# Batemans Bay Bridge replacement – Partial retention of temporary jetty piles

Addendum review of environmental factors 4

July | 2022

**SITE PLAN**  
SCALE 1:250

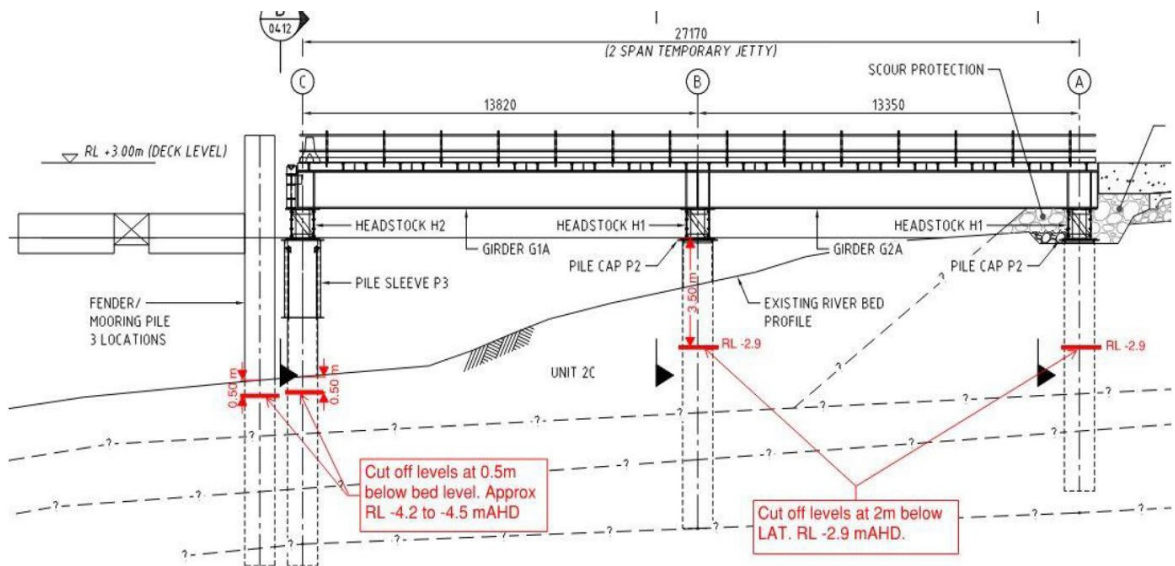
Transport for NSW proposes to modify the Batemans Bay Bridge Replacement Project by cutting off the piles of the temporary jetty, fenders and moorings below riverbed level as opposed to complete removal. The proposed modification is shown in Figure 1-3 and the general arrangement shown in Figure 3-1. Further details of the proposal can be found in Table 3-1. An indicative concept design for the new proposed cut off levels are provided in Appendix A.

**Figure 1-1 – Sketch of proposed pile cut off levels**

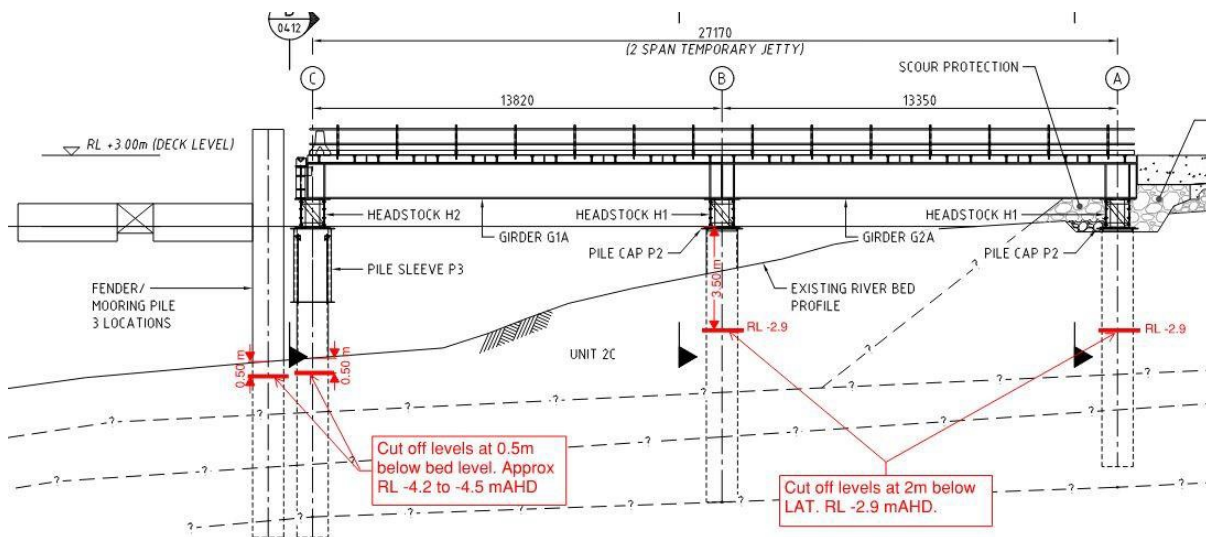
Following an assessment of the piles pull out resistance, JHG now proposes to cut off the piles at the levels displayed in Table 1-1 and shown on Figure 1-1.

Piles	Number and diameter of piles	Cut off level
Bent A	2 x 1050mm diameter, 2 x 610mm diameter	2m below LAT (RL-2.9 m AHD)
Bent B	2 x 1050mm diameter	2m below LAT (RL-2.9 m AHD)
Bent C	2 x 1050mm diameter	250-500mm below bed level (around RL-4.2 to -4.5 m AHD*)
Fender	3 x 1050mm diameter	250-500mm below bed level (around RL-4.2 to -4.5 m AHD*)
